**HISTORIC LANDMARK COMMISSION**  
**DECEMBER 12, 2011**  
**APPLICATION FOR A CERTIFICATE OF APPROPRIATENESS**  
**C14H-2011-0003**  
**Clarkson-Crutchfield House**  
**4001 Avenue G**

## The Clarkson-Crutchfield House 1905-Present C14H-2011-0003

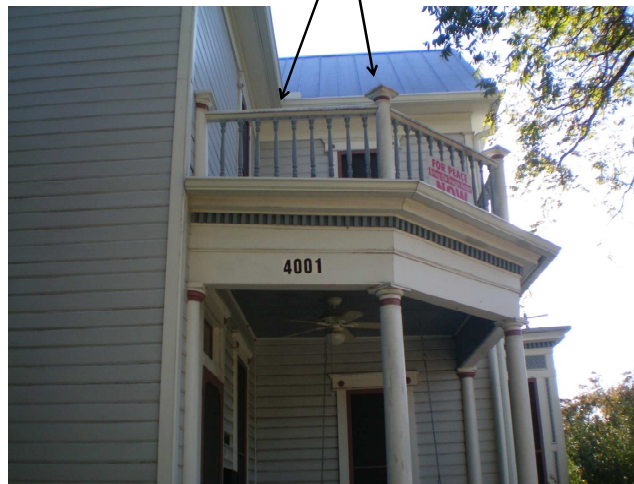
This railing and columns will be removed.
